SERVICE INFORMATION LETTER

SERVICE INFORMATION LETTER NO. T-067
Revision 2

- DATE: May 1, 2024
1. SUBJECT: Universal Block: P/N 28-14117-11 and P/N 28-14117-13
2. MODEL: 480, 480B
3. EFFECTIVITY: S/N 5254 and prior
4. BACKGROUND:

Figure 1. Universal Block Inspection Area (as indicated by the arrow)

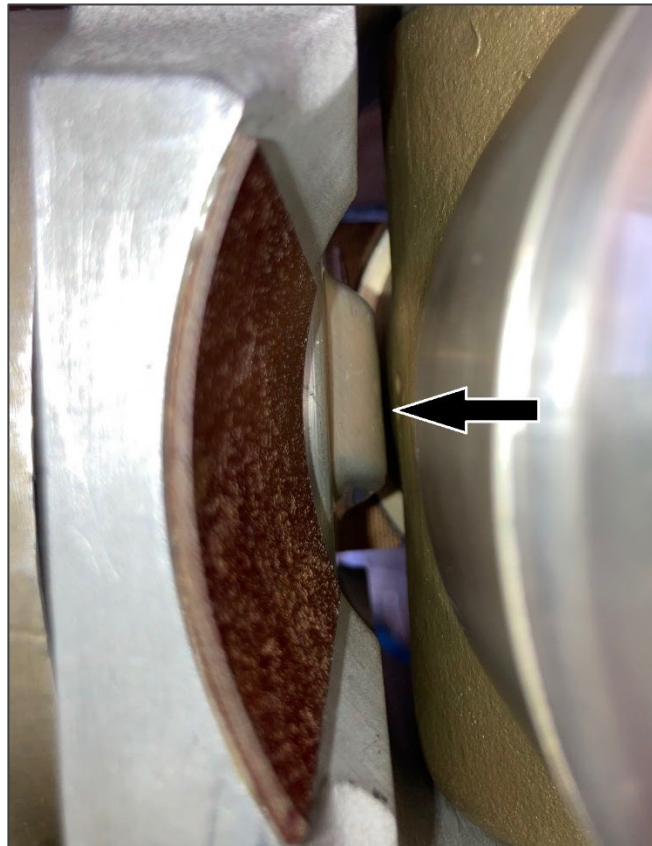
- 6.1 Using a flashlight or similar light source, visually inspect the area between the retention assembly and the U-block for contact. Refer to Figure 1 for a closeup of the area to inspect.
 - 6.1.1 If contact is evident, proceed to step 6.2. Contact would exhibit as wear marks and/or denting in the cover.
 - 6.1.2 If no evidence of contact is visible, no action is required.
- 6.2 Remove the main rotor retention assembly parts:

Figure 2. Universal Block Inspection and Rework Criteria

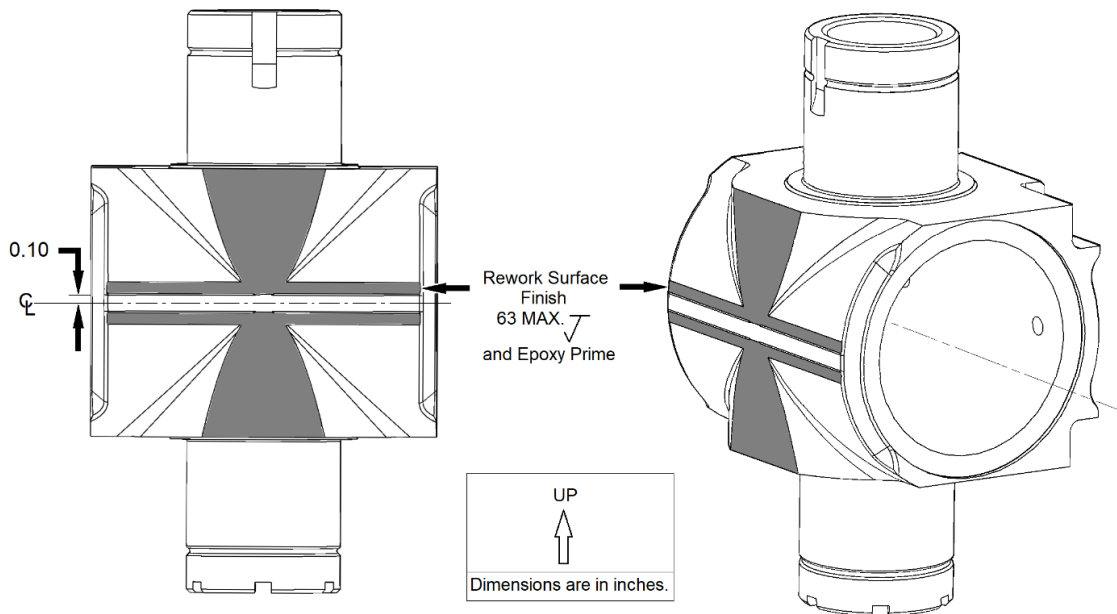
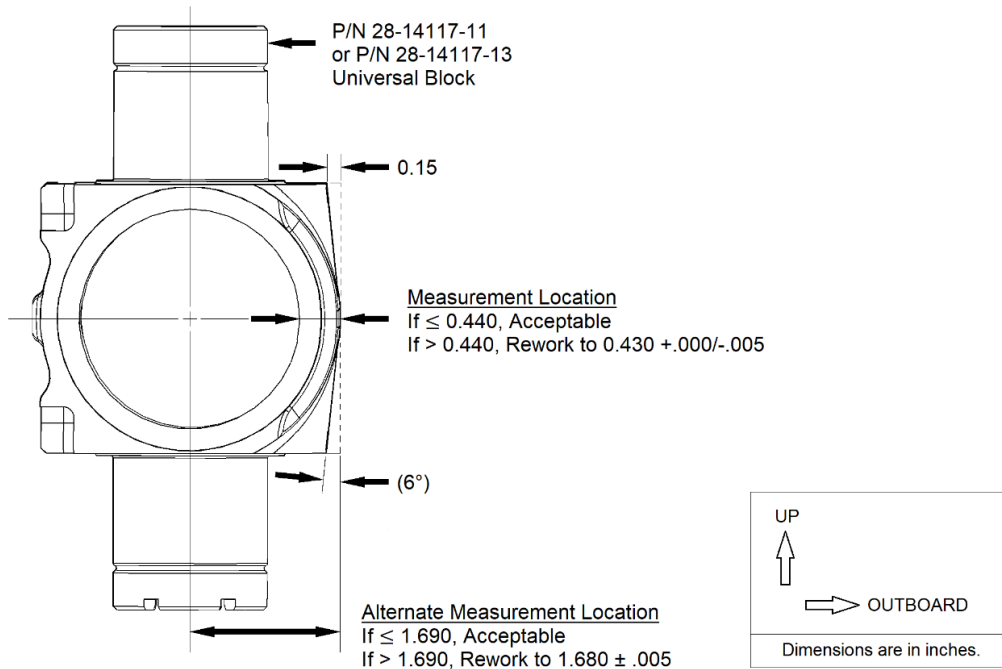
Revision 1 of this SIL introduces a modified U-block rework design and expands the affected U-block listing to include P/N 28-14117-13. (Enstrom had received a report of an instance that contact was evident after replacing a set of P/N ECD084-1 T-T straps.) This design matches the current production configuration.

- 6.2.1 P/N AA-ECD-084-480 installation: As instructed in Installation Instructions Document, AA-ECD-084-280/-480.
- 6.2.2 P/N ECD084-1 installation: As instructed in paragraph 9-14 of the MM.
- 6.3 Mill the flats and chamfer the outboard top and bottom edges as shown in Figure 2 (63 maximum surface finish).
- 6.4 Epoxy prime the reworked surface. (Epoxy primer may be procured from a local source.)
- 6.5 Re-install the retention assembly:
